Enclosure 1 provides a summary of the changes. Enclosure 2 provides a new set of TS markups. Enclosure 3 provides a new set of TS Bases markups.

TENNESSEE VALLEY AUTHORITY (TVA) SEQUOYAH NUCLEAR PLANT (SQN) SUPPLEMENT TO SQN UNIT 2 TECHNICAL SPECIFICATION (TS) CHANGE 05-09

New TS Page Markups for TS Change 05-09

6.9.1.16.3

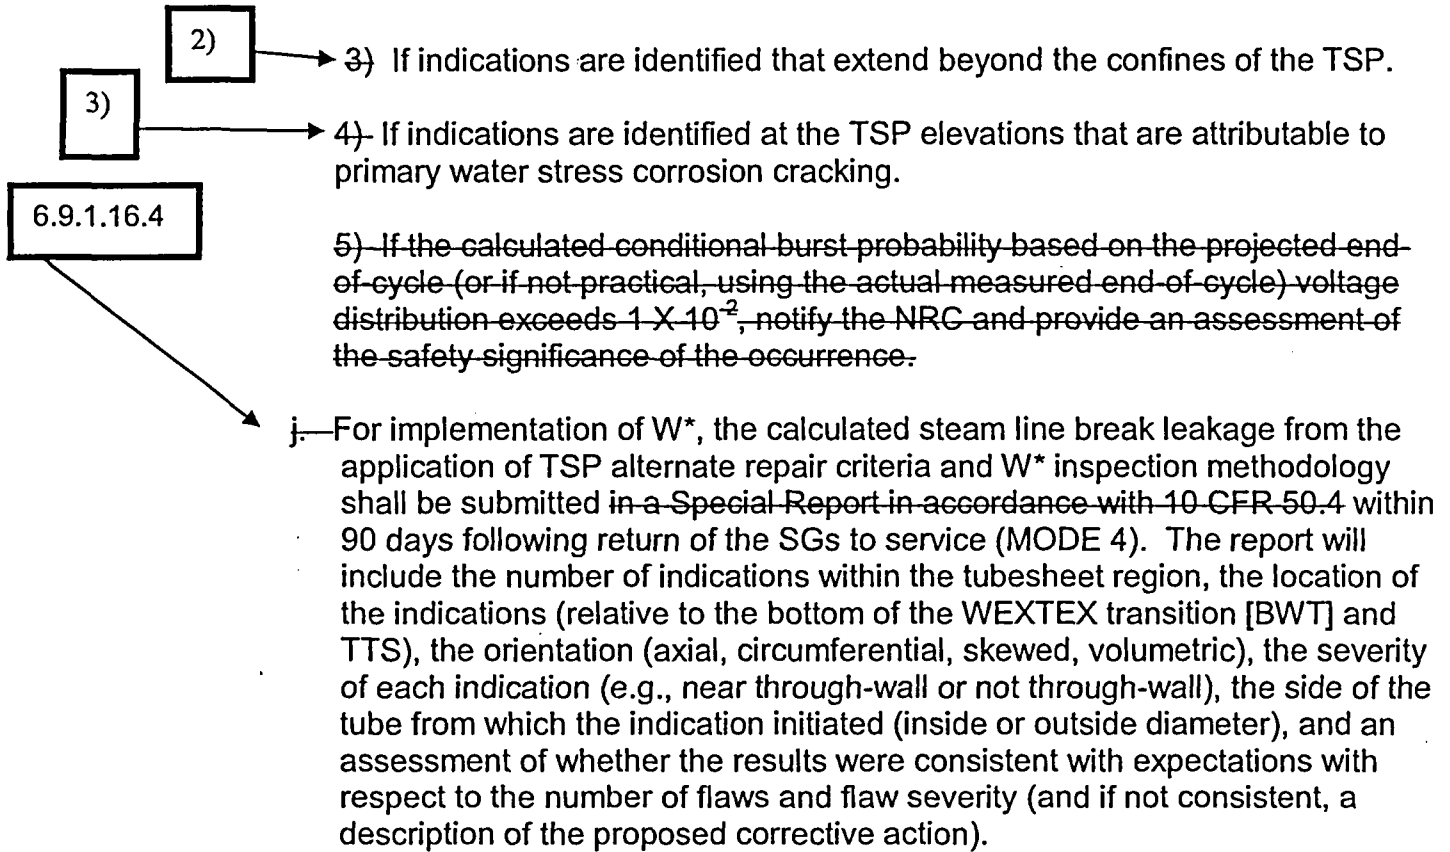
- i. For implementation of the voltage-based repair criteria for tube support plate (TSP) intersections, notify the staff prior to returning the SGs to service should any of the following conditions arise:

~~1) Leakage is estimated based on the projected end-of-cycle (or if not practical using the actual measured end-of-cycle) voltage distribution. This leakage shall be combined with the postulated leakage resulting from the implementation of the W* criteria to tubesheet inspection depth. If the total projected end-of-cycle accident induced leakage from all sources exceeds the leakage limit (determined from the licensing basis dose calculation for the postulated main steam line break) for the next operating cycle, the staff shall be notified.~~
